**From:** John Grobe  
**To:** Eric Duncan  
**Date:** Wed, May 9, 2007 10:09 AM  
**Subject:** Fwd: FirstEnergy Nuclear Operating Company (FENOC) Exponent Failure Analysis Associates' Technical Report

Summary Report  
May 2007

**Effect of Exponent Analysis of  
Davis-Besse Reactor Vessel Head Wastage Event  
On Industry Inspection Programs**

**Figure 2-1**  
**Davis-Besse Crack Growth Rates Relative to MRP-55 Data**

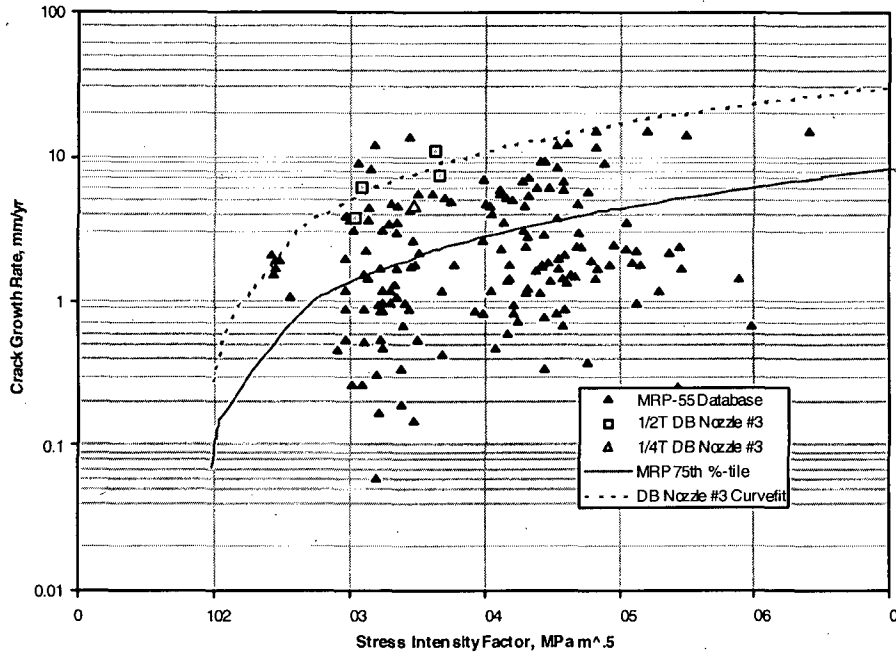
Exponent states that the crack growth rates of the Davis-Besse CRDM nozzle material were up to four times the growth rate of the MRP recommended 75<sup>th</sup> percentile crack growth curve reported in MRP-55. While this statement is correct, Figure 2-1 from MRP-55 shows that some of the material specimens in the MRP-55 database had crack growth rates even higher than the Davis-Besse material. Therefore, the Davis-Besse material is considered to be within the bounds of previously evaluated materials.

**Figure 2-2**  
**Projected Crack Growth and Industry Examination Requirements for a High Temperature Head under Crack Growth Rate Conditions Postulated in Exponent Report**

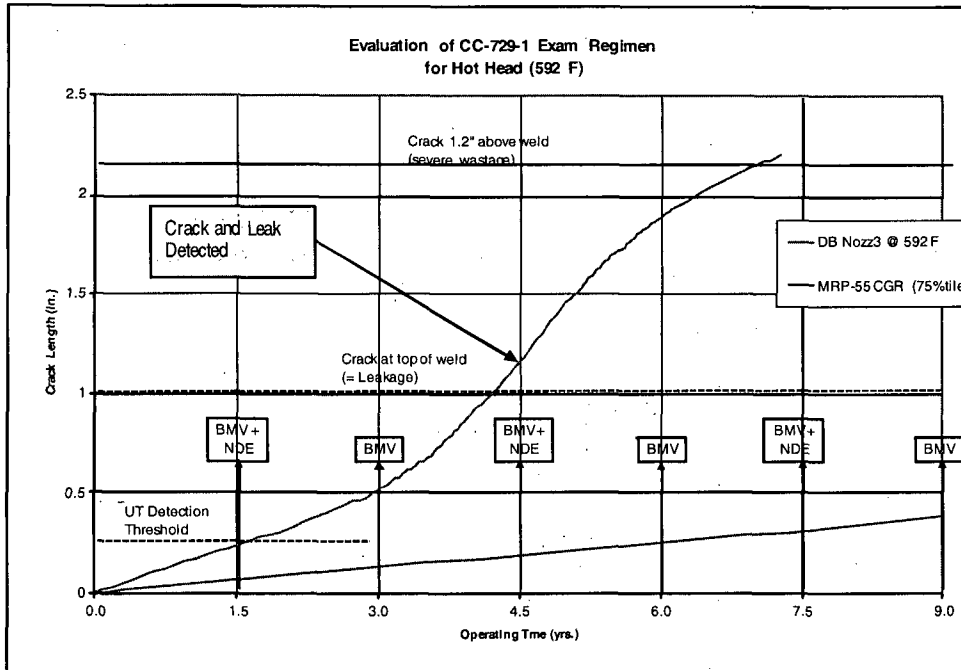
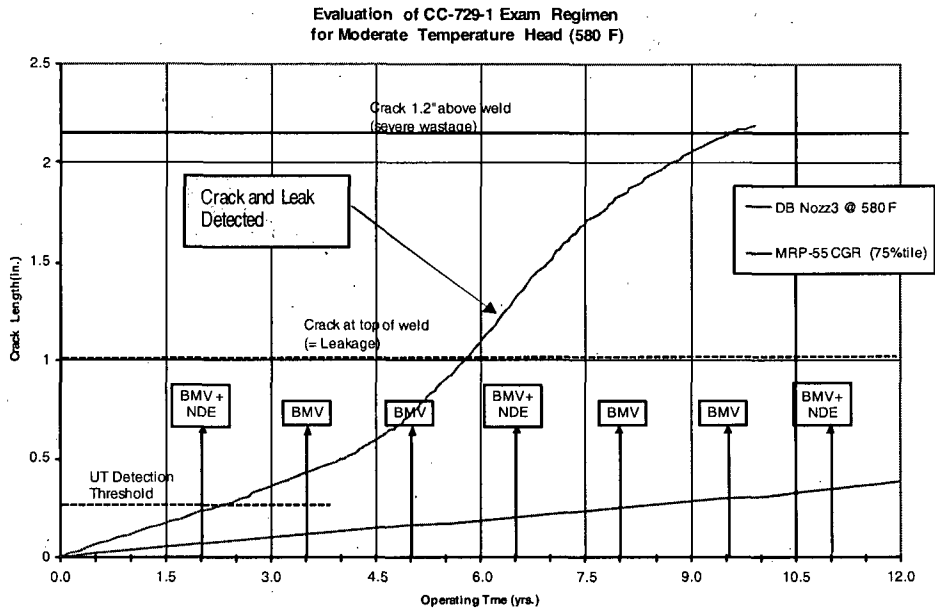
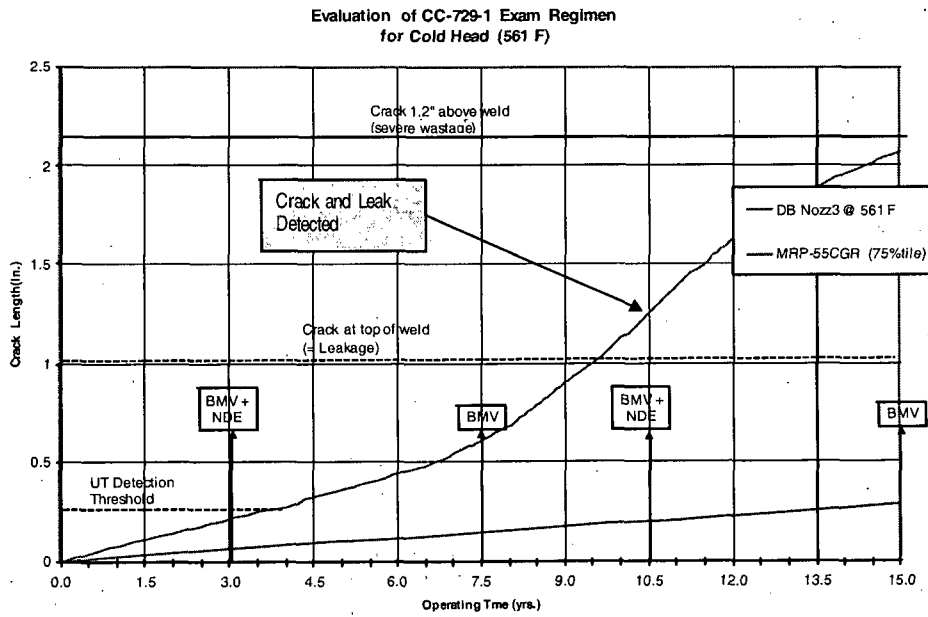
Deterministic predictions of crack growth for the three sample cases, using the crack growth rate curve for Davis-Besse Nozzle 3 referenced in the Exponent report are presented in Figures 2-2, 2-3 and 2-4. In each case, the crack growth rate equation was adjusted to the appropriate head operating temperature in accordance with the Arrhenius equation for crack growth (MRP-55<sup>1</sup>). The figures also show the predicted crack growth in accordance with the MRP-55 75<sup>th</sup> percentile crack growth law for comparison purposes. Several significant crack sizes are shown as horizontal dashed lines on the figures, corresponding to the crack length at which detection by UT would be expected with high confidence (conservatively assumed = 0.25"), the crack length corresponding to the crack at the top of the weld, at which leakage is predicted, and a crack length of 1.2" above the weld, corresponding to the crack length that was discovered at Davis-Besse in 2002. Finally, vertical arrows are plotted on the figures corresponding to the NDE and BMV inspections that would be required at various refueling outages, per Table 2-1 above. Since inspections required per the NRC Order are somewhat more conservative than those required by Code Case N-729-1, only those required per the Code Case are shown on the figures. This produces the most conservative evaluation of the potential effect of the Exponent crack growth rate, since it corresponds to the least amount of inspection that would possibly be performed in the future. Also for conservatism, the initial baseline inspection was assumed to occur at a time when the postulated crack is just below the UT inspection threshold, and would thus be missed.

Figures 2-2 through 2-4 show that for each hypothetical case an NDE + BMV would be performed shortly after the postulated cracks are projected to reach the top of the welds, such that they would be well above the detection threshold of the ultrasonic NDE, and evidence of leakage would likely be detected by the BMV as well. These exams would be performed, and the cracking detected, well before the crack length approached the size predicted to have caused the severe wastage observed in the Davis-Besse head. These results, plus the conservative bounding nature of the deterministic evaluation, were a major factor in the panel's conclusion regarding adequacy of the current industry RPV top head examination program.
